Access Compliance Report

Public Rights-of-Way

(Curb Ramps)

Intersection ID: 4753	Main Street: LOWEN_RD	Cross Street: SADDLE_TRAIL_LN	Location: E
ADA ID: 05BB97727EF1	Ramp Type: Perp	Initial Pass/Fail: Fail	Overall Compliance: No
			Severity Score: 46.25

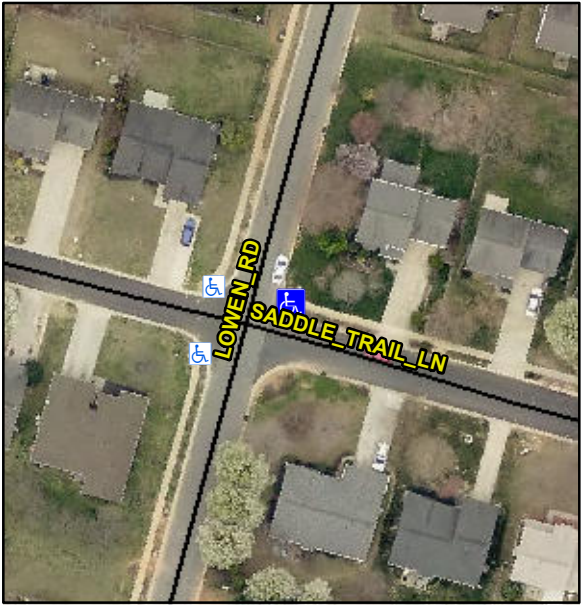
Codes/Mitigation Info/Possible Solution		Field Measurements/Component Compliance			
	Possible Solutions:				
	Remove & Replace Entire Ramp.				
	Surveyor Notes:				
	N/A				
	PROW/ADA:				
	Not Found, R304.5.1, R304.2.2, R304.5.3				
	Street 1 Name	LOWEN RD			
	Stop Condition-Street 2	None			
	Street 2 Name	N/A			
	Stop Condition-Street 1	N/A			
Total Cost:		\$	1850.00		
Compliance	Description	Data	Compliance	Description	Data
N/A	Ramp Length (in)	51.5	No	Ramp Slope (%)	11.8
No	Ramp Width (in)	36.0	No	Ramp XSlope (%)	9.6
N/A	Flare Type LT	N/A	N/A	Flare Type RT	N/A
N/A	Flare Slope LT (%)	N/A	N/A	Flare Slope RT (%)	N/A
N/A	Flare Traversable LT?	N/A	N/A	Flare Traversable RT?	N/A
N/A	Landing Length (in)	N/A	N/A	DWS Provided?	N/A
N/A	Landing Width (in)	N/A	N/A	DWS Contrast?	N/A
N/A	Landing Slope (%)	N/A	N/A	DWS Length (in)	N/A
N/A	Landing X Slope (%)	N/A	N/A	DWS Full Width?	N/A
N/A	Landing Curb? (Y/N)	N/A	N/A	DWS Offset (in)	N/A

N/A	Shared Landing?	N/A			
N/A	Gutter Ponding?	N/A	N/A	Gutter Slope (%)	N/A
N/A	Gutter Lip Ht (in)	N/A	N/A	Gutter X Slope (%)	N/A
N/A	Painted X Walk1?	No	N/A	Painted X Walk2?	N/A
	X Walk 1 Direction	To NW		X Walk 2 Direction	N/A
N/A	X Walk 1 Width (in)	N/A	N/A	X Walk 2 Width (in)	N/A
	X Walk 1 Slope (%)	2.1		X Walk 2 Slope (%)	N/A
	X Walk 1 X Slope (%)	10.5		X Walk 2 X Slope (%)	N/A
N/A	Ramp inside XWalk1?	N/A	N/A	Ramp inside XWalk2?	N/A
	Road Slope (%)	N/A	N/A	Clear Space?	N/A
	Road X Slope (%)	N/A	N/A	Clear Space to XWalk (in)	N/A
N/A	Any Obstructions?	N/A	N/A	Storm Grate/Utility Hazard?	N/A
	Obstruction Type			Storm Grate/Utility Type	
		N/A			N/A
			Yes	Surface Condition? (G/P)	Good
